**GOVERNMENT OF THE DISTRICT OF COLUMBIA
DEPARTMENT OF CONSUMER AND REGULATORY AFFAIRS
OFFICE OF THE ZONING ADMINISTRATOR**

Re: Zoning PDRM – 1710 10th Street, NW – Subject Property – Zone RF-1, Square 0335, Lot 0820

Attachments- Plan Set dated 6-28-16

HPRB - EAST ELEVATION
1/4" = 1'-0"

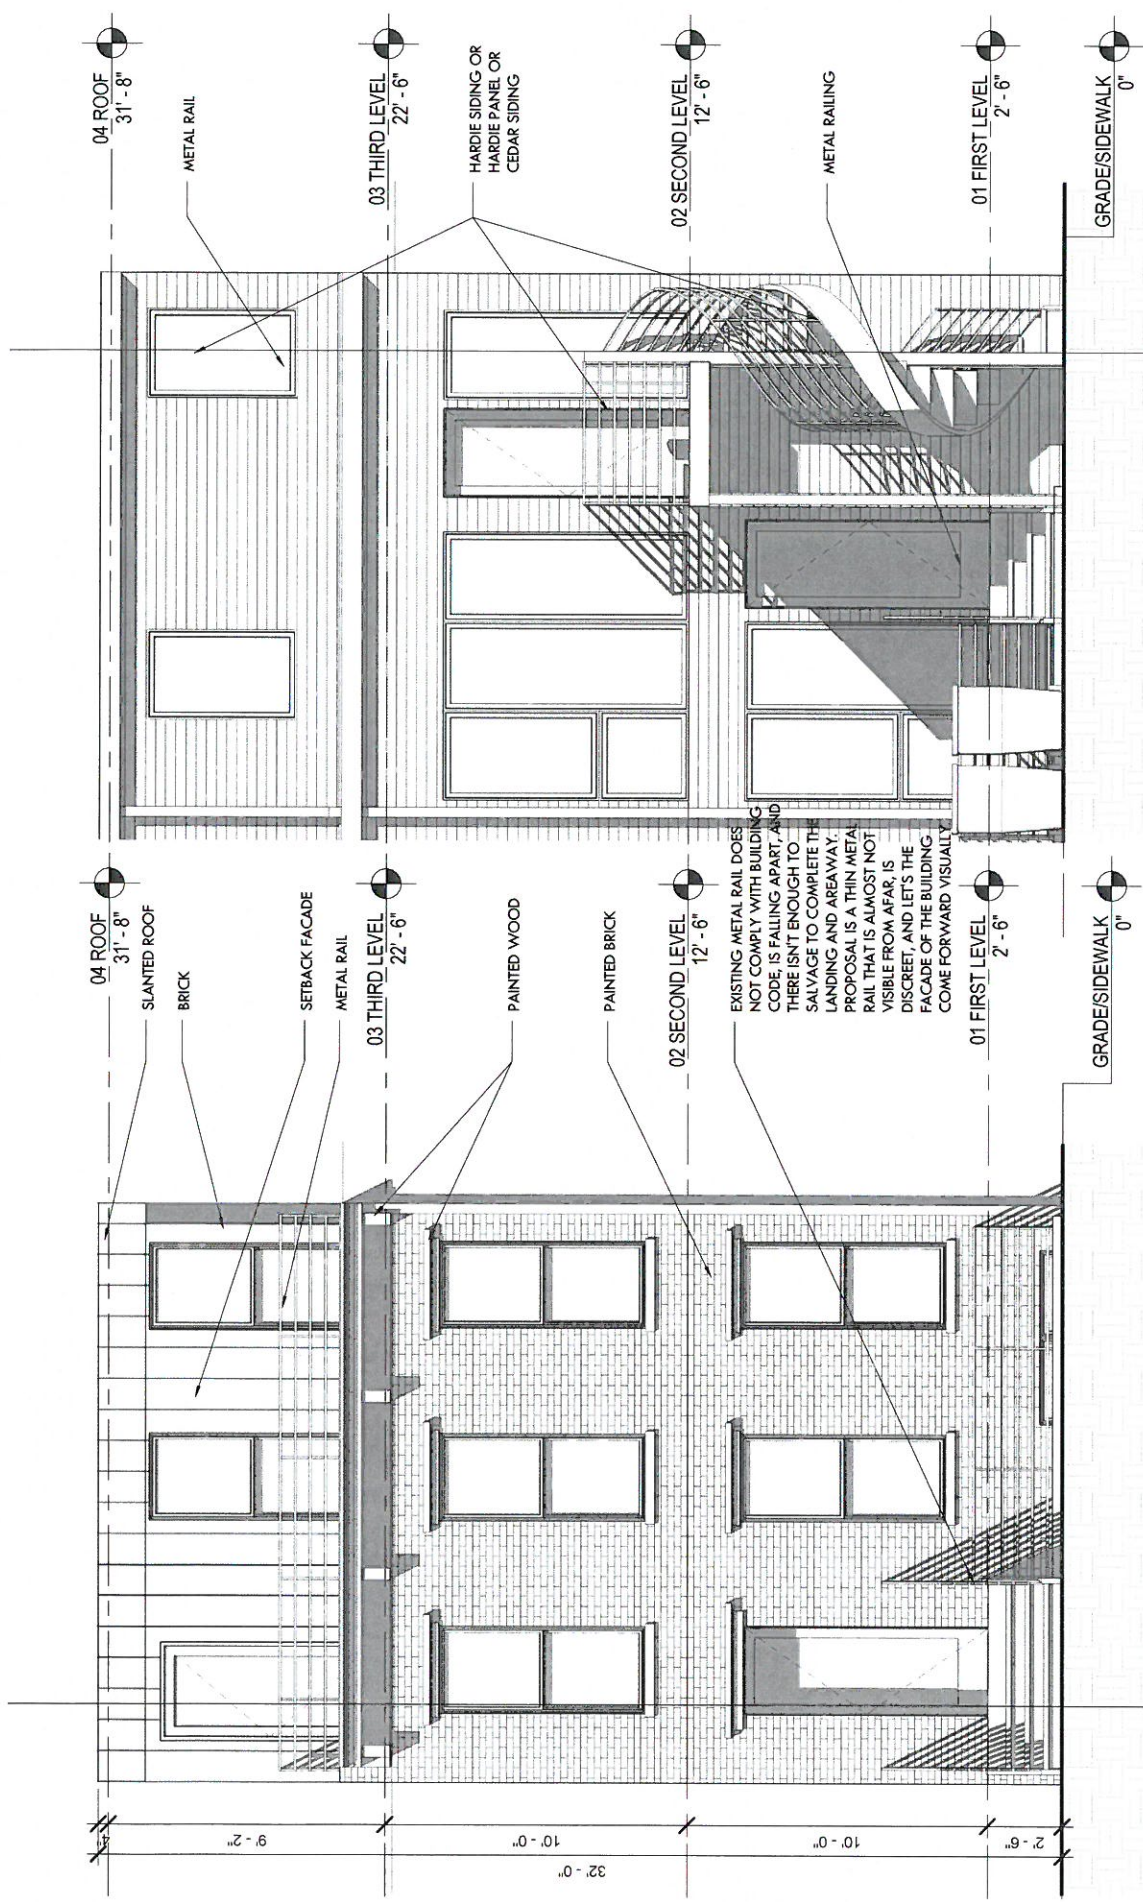
1 – The project is a matter of right conversion from a single-family house to a two-dwelling unit flat in the subject RF-1 zone. The scope of work includes a rear addition and a partial third floor addition with roof deck. The rooftop architectural cornice element is being preserved, as shown on the East Elevation-Sheet PT 1.3.
